HILLSTA

UNIT #38 (Annex B3)

TYPE T2a

BP NO. : A1606-00001-2011 BP01

UNIT #56 (Annex B3)

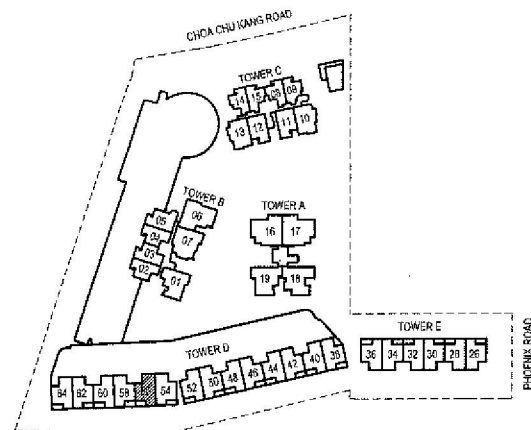
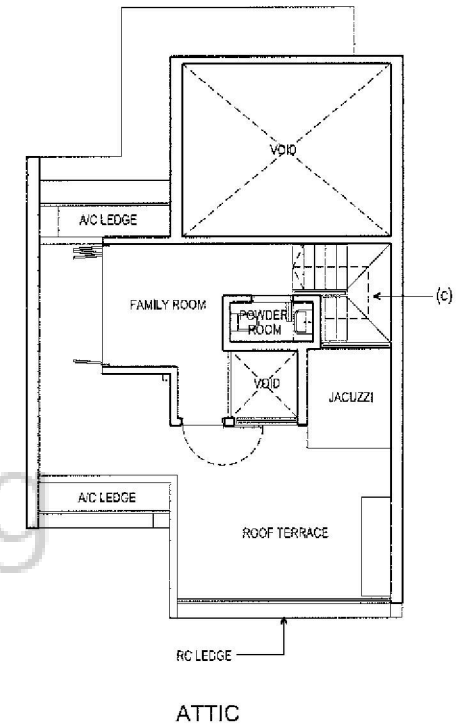
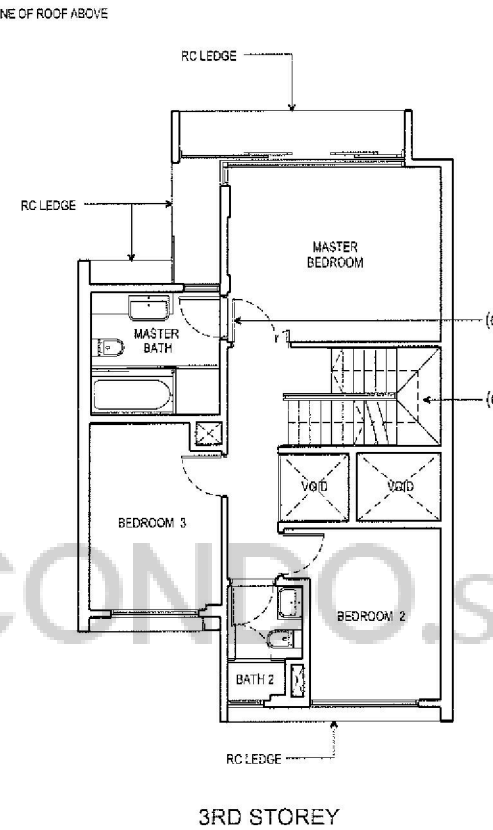
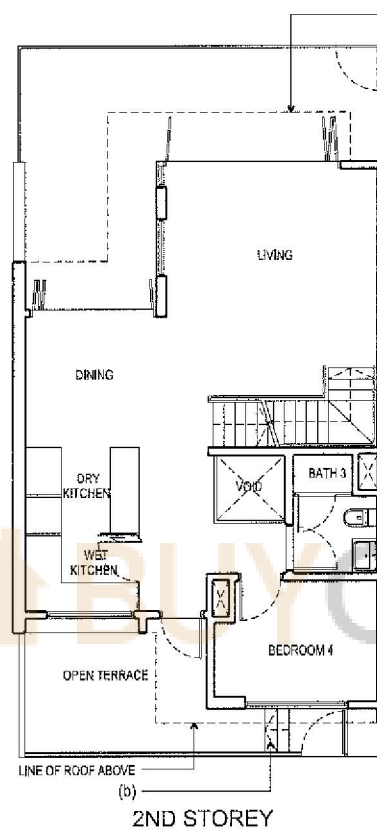
CHANGES TO BE SUBMITTED IN THE NEXT BP AMENDMENT ARE SHOWN IN THESE PLANS:

- (a) RELOCATION OF METERING
- (b) NUMBER OF STEPS AT OPEN TERRACE
- (c) STEPS AT LANDING HAD BEEN RELOCATED TO UPPER FLIGHT
- (d) REMOVAL OF WINDOWS AND ADDITION OF MECHANICAL VENTILATION
- (e) 2 LEAVES TYPE DOOR CHANGED TO 1.5 LEAF TYPE DOOR

UNIT #58 (Annex B3)

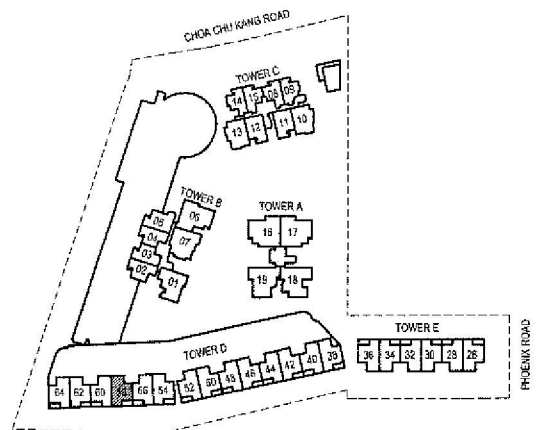
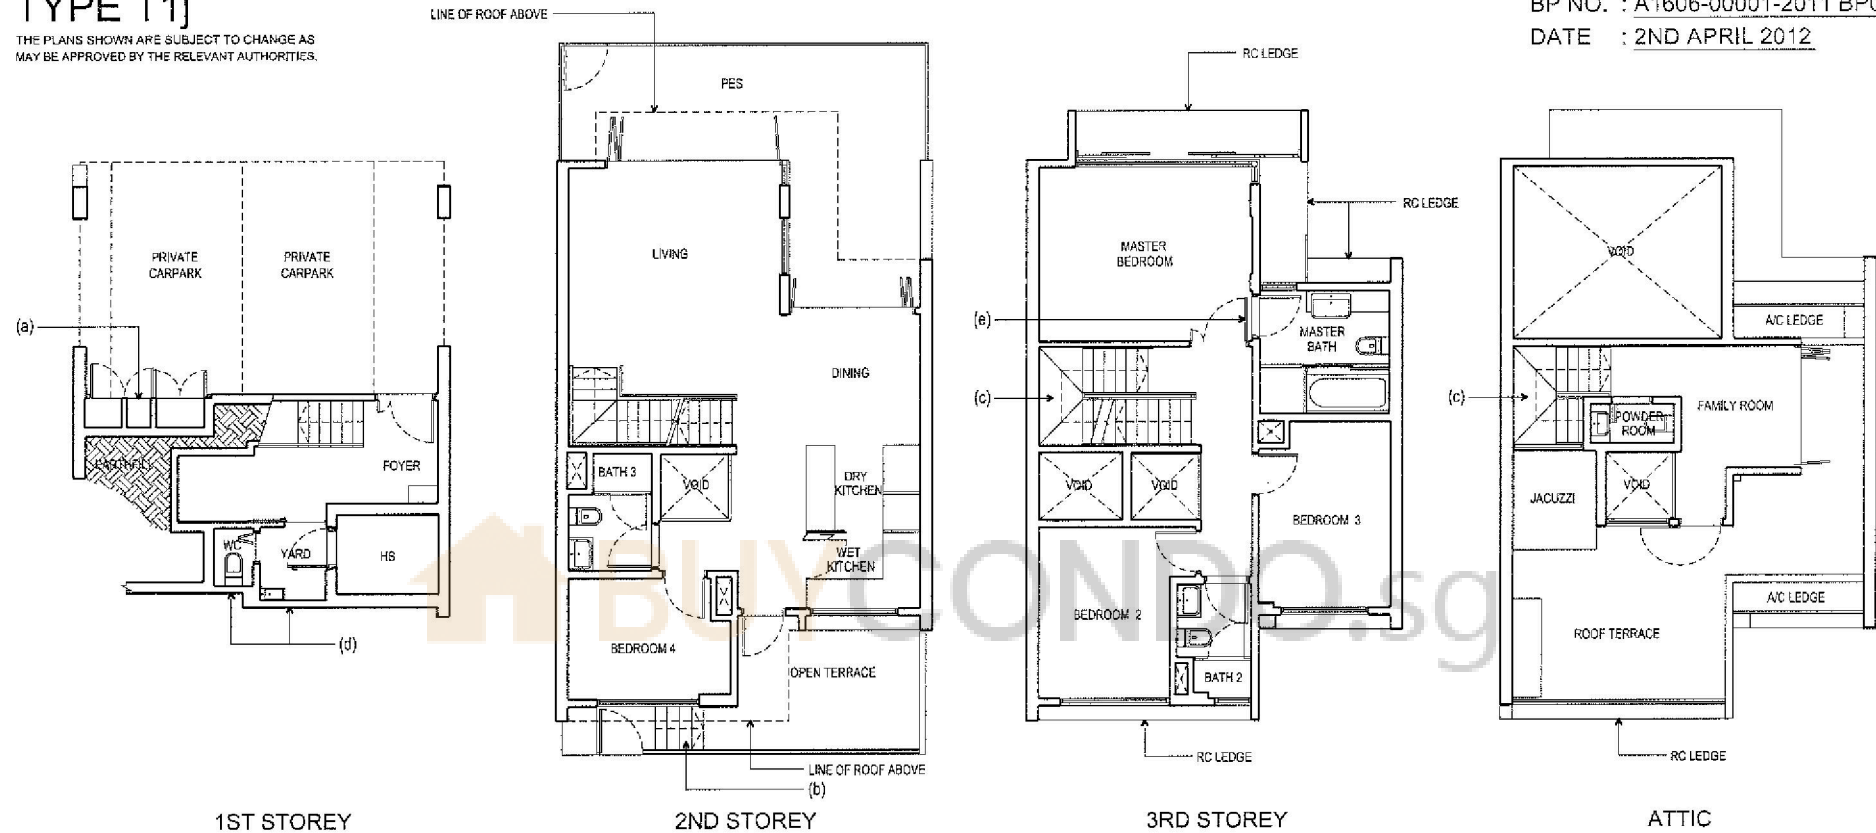
CHANGES TO BE SUBMITTED IN THE NEXT BP AMENDMENT ARE SHOWN IN THESE PLANS:

- (a) RELOCATION OF METERING
- (b) NUMBER OF STEPS AT OPEN TERRACE
- (c) STEPS AT LANDING HAD BEEN RELOCATED TO UPPER FLIGHT
- (d) REMOVAL OF WINDOWS AND ADDITION OF MECHANICAL VENTILATION
- (e) 2 LEAVES TYPE DOOR CHANGED TO 1.5 LEAF TYPE DOOR

UNIT #60 (Annex B3)

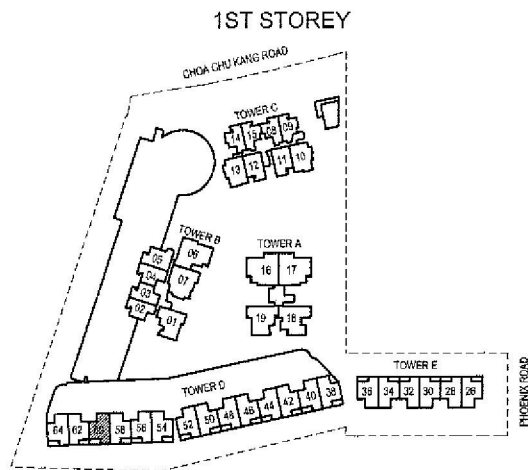
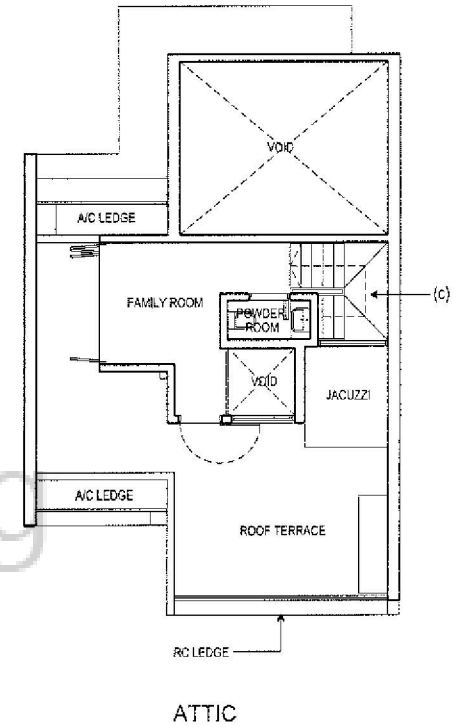
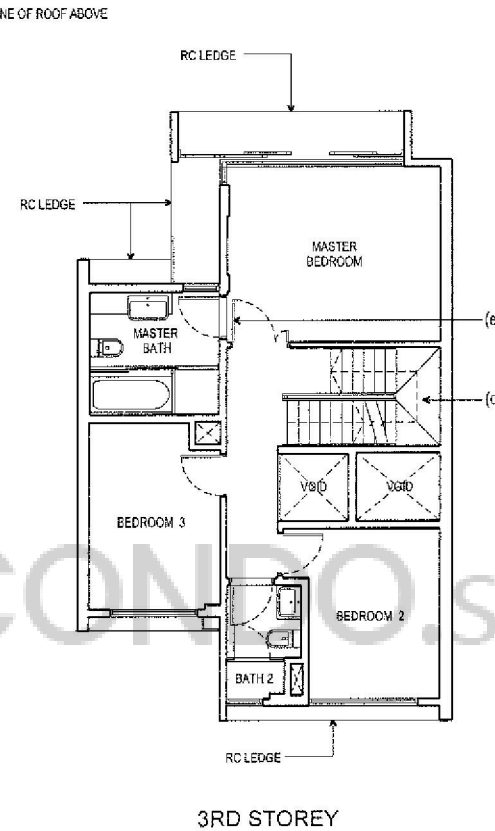
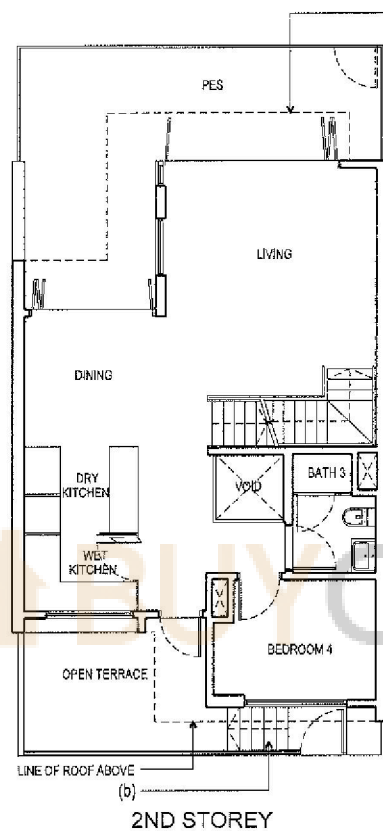
- CHANGES TO BE SUBMITTED IN THE NEXT BP AMENDMENT ARE SHOWN IN THESE PLANS:
- (a) RELOCATION OF METERING
 - (b) NUMBER OF STEPS AT OPEN TERRACE
 - (c) STEPS AT LANDING HAD BEEN RELOCATED TO UPPER FLIGHT
 - (d) REMOVAL OF WINDOWS AND ADDITION OF MECHANICAL VENTILATION
 - (e) 2 LEAVES TYPE DOOR CHANGED TO 1.5 LEAF TYPE DOOR
